ATTACHMENT A

Technical Specification
Page Revisions

Indian Point Unit No. 2

Docket No. 50-247

Figure 3.10-2 a

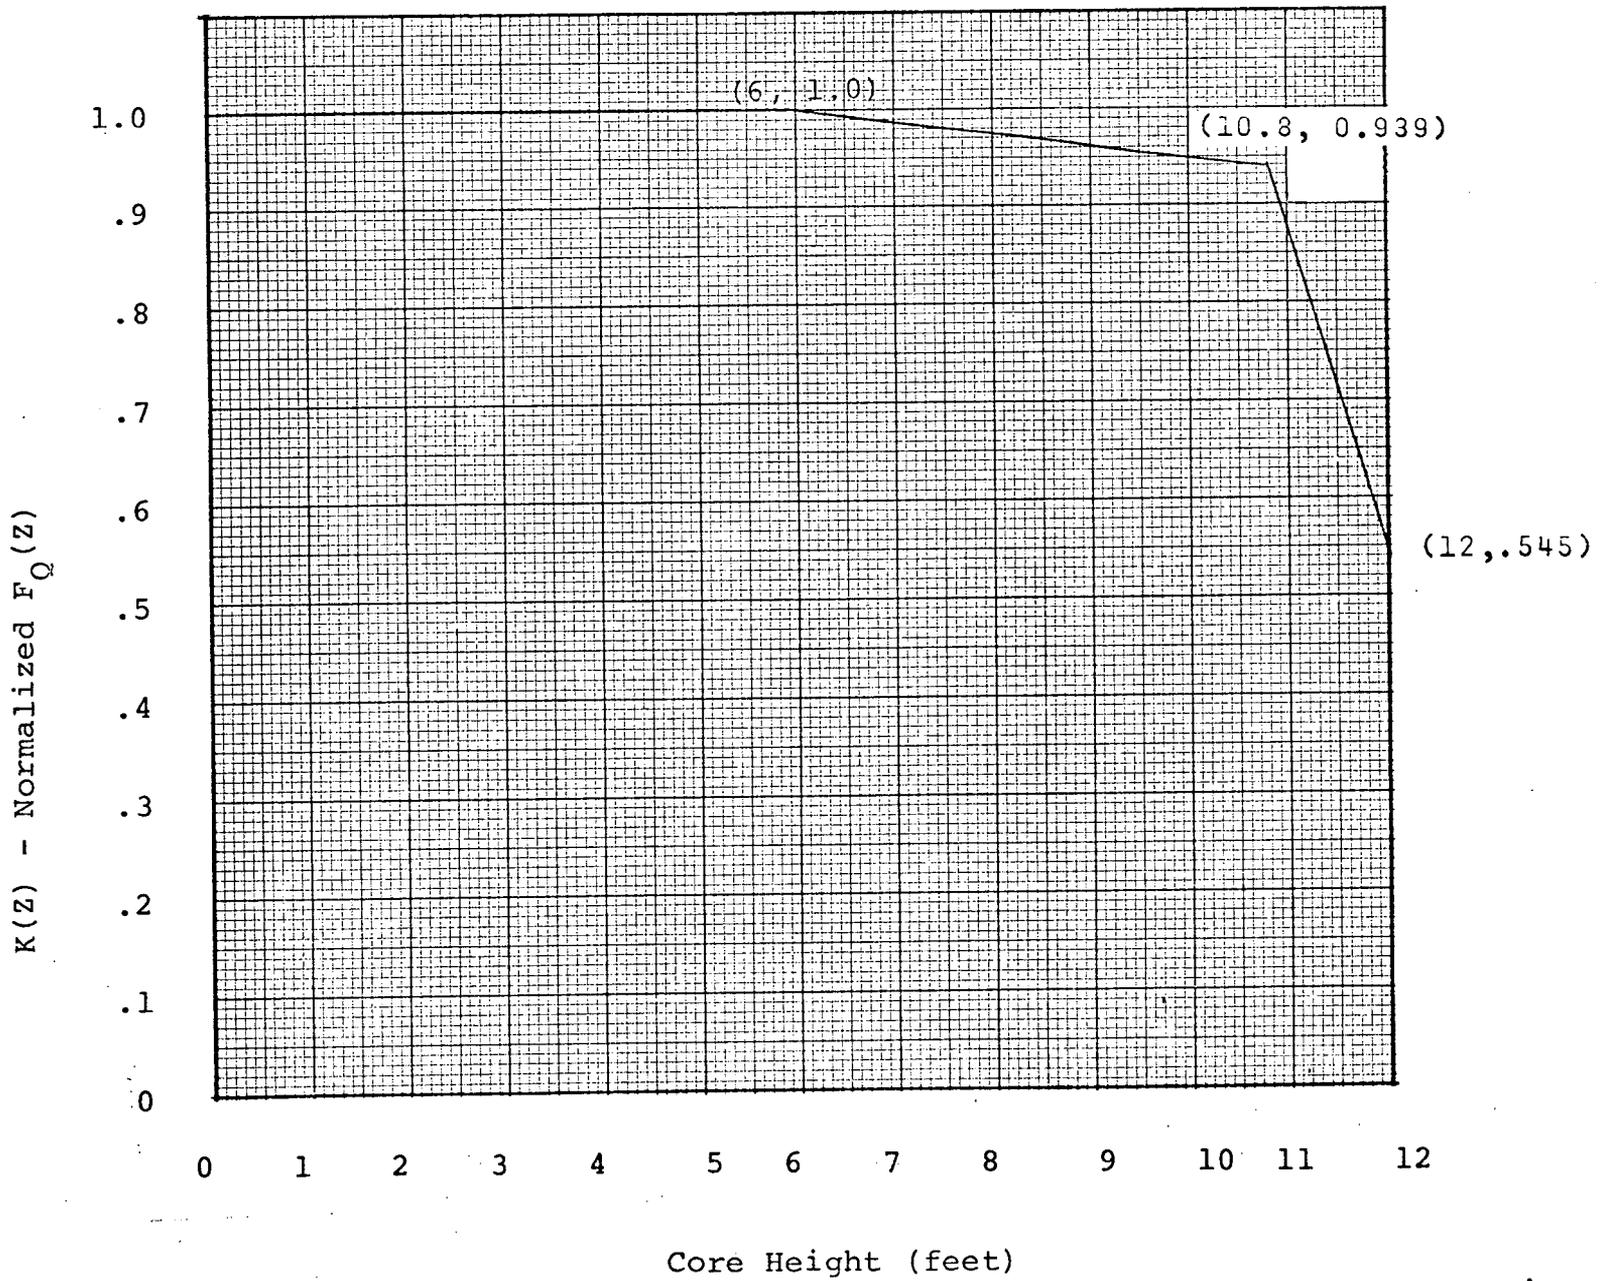
(c) For $> 6\%$ but $\leq 12\%$ steam generator tube plugging:

$$F_Q(Z) \leq (2.25/P) \times K(Z) \text{ for } P > .5$$

$$F_Q(Z) \leq (4.50) \times K(Z) \text{ for } P \leq .5$$

where P is the fraction of full power at which the core is operating; K(Z) is the fraction given in Figure 3.10-2a (for $\leq 6\%$ tube plugging) or Figure 3.10-2b (for $> 6\%$ but $\leq 12\%$ tube plugging); and Z is the core height location of F_Q .
